The Land Drainage Solution to manage effluent flow from Cambourne.

Delivery of the LDS

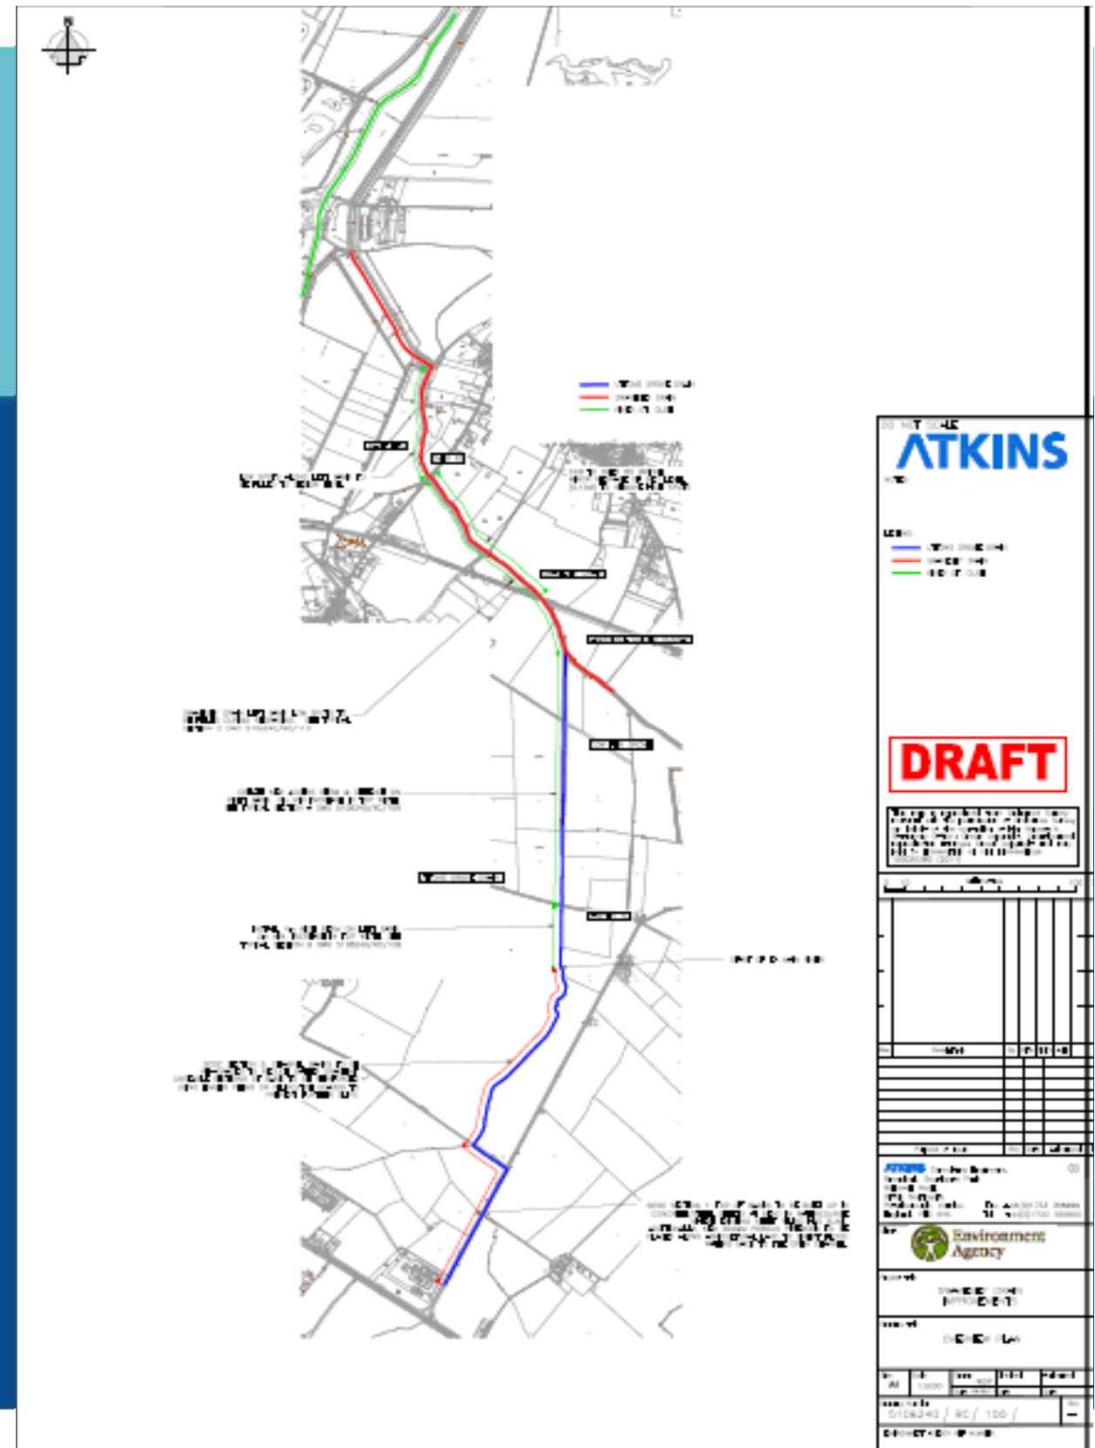
- Sections 1 and 2 SCDC works
- Section 3 New Berm
- Section 4 New Berm & Defence
- Section 5 Reinststate flood bank
- Section 6 Desilt channel
- Section 7 Raise low spots on flood bank
